MFN 07-160

Subject: **Topical Report NEDO-33288 – APPLICATION OF NUCLEAR MEASUREMENT ANALYSIS AND CONTROL (NUMAC) FOR THE ESBWR REACTOR TRIP SYSTEM**

**Markup Index Table and
Chapter 7 DCD Tier 1 and Tier 2, Proposed Markups for
DCD Revision 4**

Figure 2.2.5-1. Basic Configuration of a Typical SRNM Division (Subsystem)

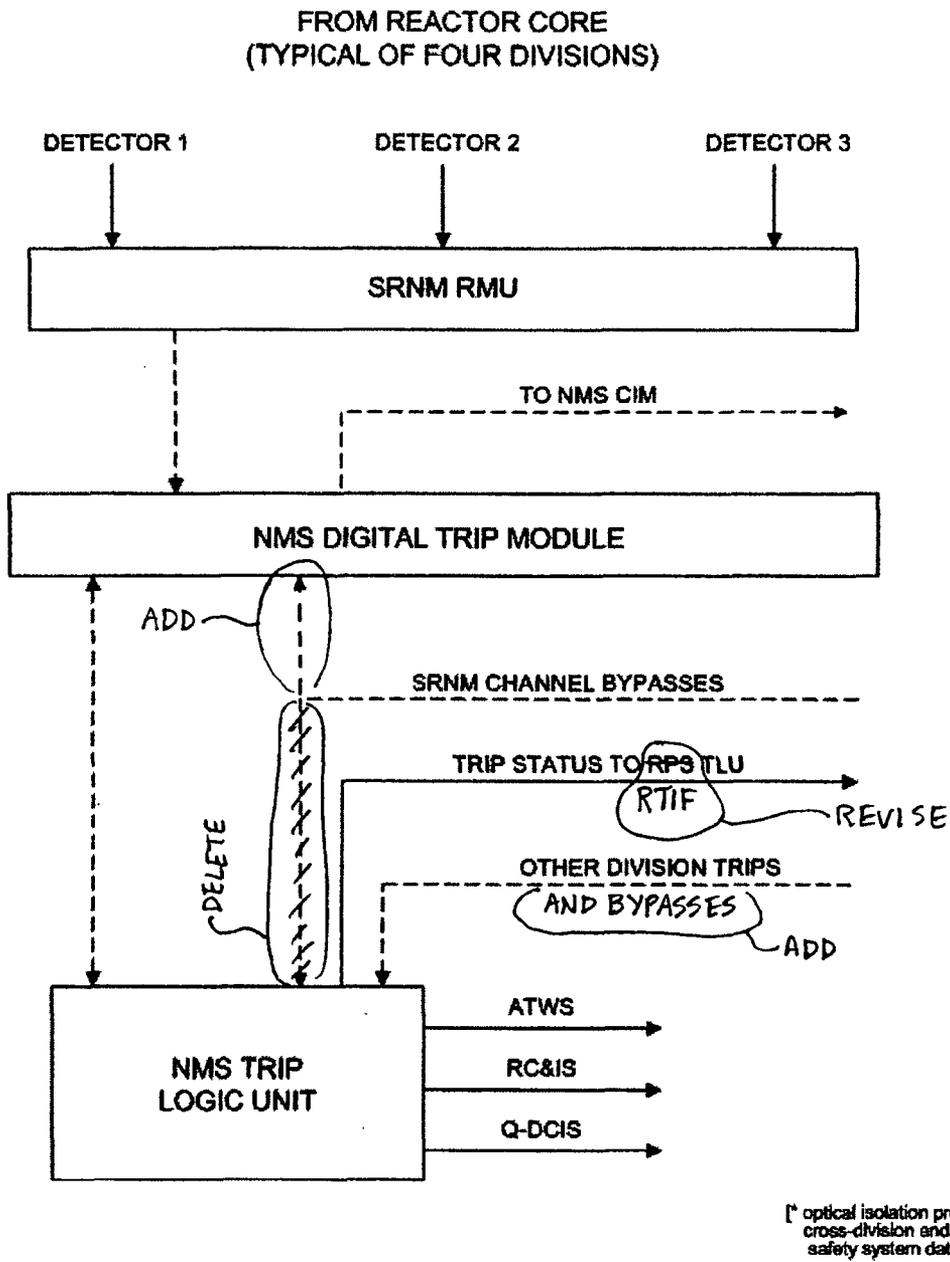
Markup Index Table		
Tier	Section	Item
1	2.2.5	5 th paragraph, 4 th sentence
1	2.2.5	11 th , 12 th , 13 th paragraphs, last sentences
1	Table 2.2.5-1	8 th item, Design Commitment wording
1	Figure 2.2.5-1	Altered figure
1	Figure 2.2.5-2	Altered figure
1	Figure 2.2.7-1	Altered notes
1	2.2.10	1 st paragraph, 1 st sentence
1	2.2.12	4 th Paragraph, 3 rd sentence
1	Table 2.2.14-1	9 th item, Design Commitment and Acceptance Criteria wording
2	Abbreviation List	RPS/RTIF entry
2	7.1.2	First bulleted item
2	7.1.2.8.1	1 st paragraph, 1 st Sentence.
2	7.1.2.8.1	4 th paragraph, 2 nd sentence
2	7.1.2.8.3.5	Last sentence
2	7.1.2.8.3.6	1 st paragraph, last sentence
2	7.1.2.8.3.6	2 nd paragraph, first sentence
2	7.1.2.8.3.8	2 nd paragraph, last sentence
2	7.1.2.8.4.1	Last sentence
2	7.1.6.6.1.18	1 st paragraph, last sentence
2	7.1.8	Revised reference 7.1-6
2	7.2.1.2.4.1	3 rd paragraph, 9 th sentence
2	7.2.2.1	Last paragraph, 3 rd sentence

REVISE

Figure 7.2-1. RPS Functional Block

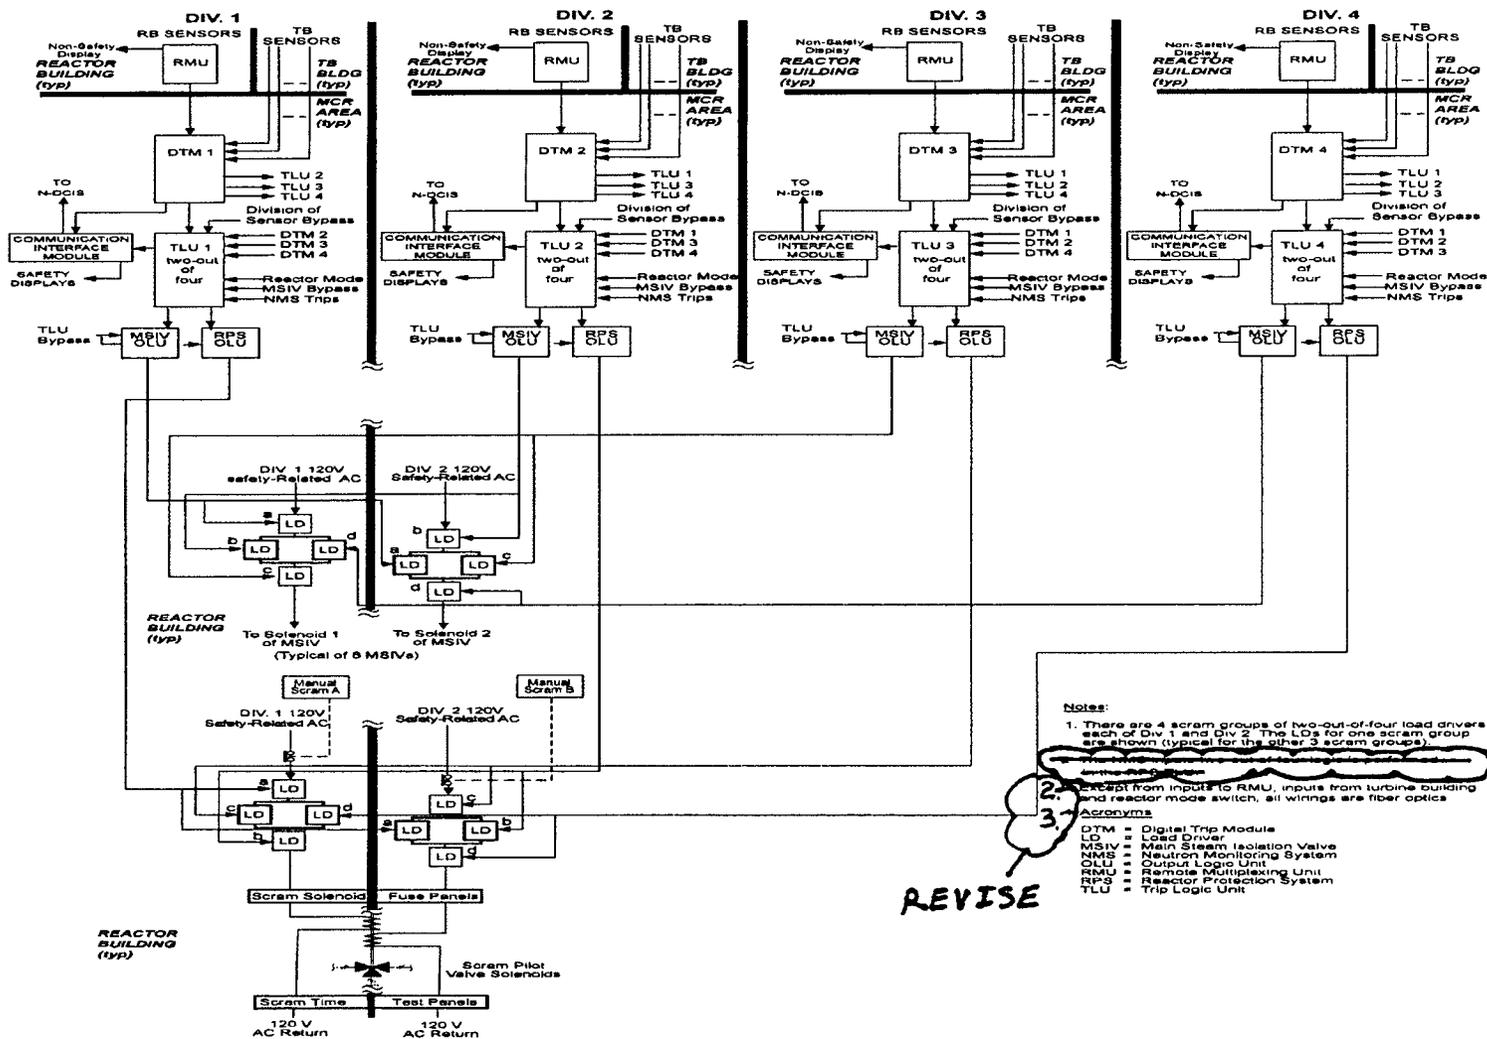
2	7.2.2.2.4.3	1 st paragraph, 11 th sentence
2	7.2.2.2.4.6	1 st paragraph, 4 th sentence
2	7.2.2.2.4.6	1 st paragraph, 7 th sentence
2	7.2.2.2.4.7	3 rd sentence
2	7.2.2.2.6.1	Last sentence
2	7.2.2.2.6.6	1 st paragraph, 3 rd and 4 th sentences
2	7.2.2.2.6.6	2 nd paragraph, 3 rd sentence
2	7.2.2.2.6.7	1 st sentence
2	7.2.2.2.7.1	Last sentence
2	7.2.2.2.7.4	3 rd paragraph, first sentence
2	7.2.2.6.2	5 th paragraph, last sentence
2	7.2.2.6.2	6 th paragraph, 3 rd and last sentences
2	7.2.2.6.2	8 th paragraph
2	7.2.2.6.2	9 th paragraph (significant re-wording throughout)
2	Figure 7.2-1	Altered Notes
2	Figure 7.2-4	Altered Figure

Figure 7.2-5. Basic Configuration of a Typical PRNM Subsystem

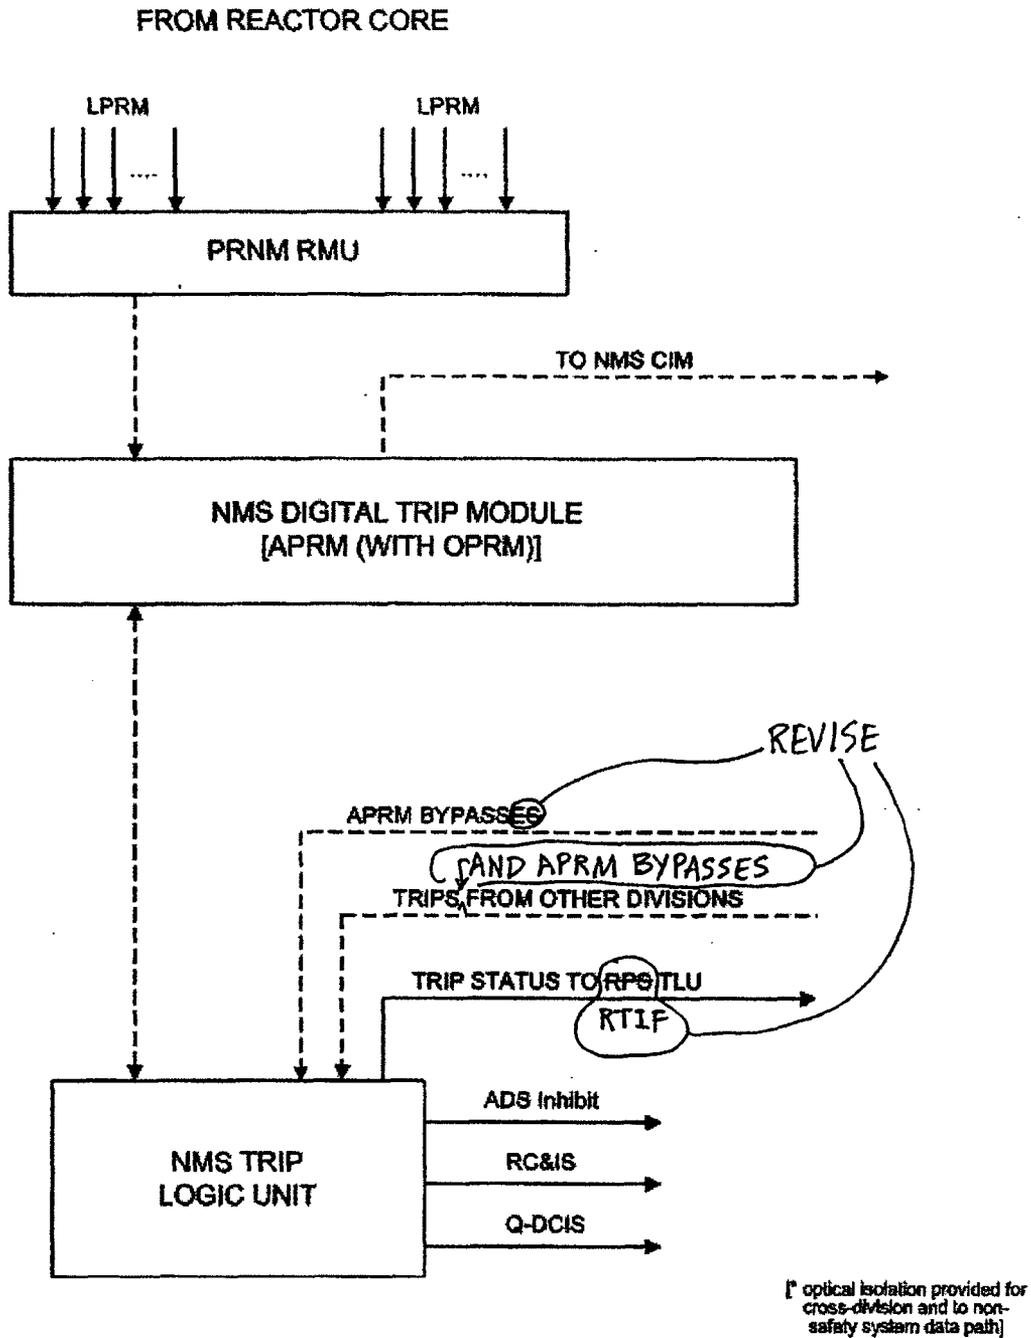
Markup Index Table		
Tier	Section	Item
2	Figure 7.2-5	Altered Figure
2	Table 7.2-6	Wording under Action column for OPRM Oscillation Detection
2	7.3.3	Last sentence
2	7.3.3.2	1 st paragraph, last sentence
2	7.3.3.4.1	3 rd paragraph
2	7.3.5.5	3 rd paragraph, 4 th sentence
2	7.7.2.2.1, Emergency Rod Insertion Control Panel (ERICP) section	3 rd sentence
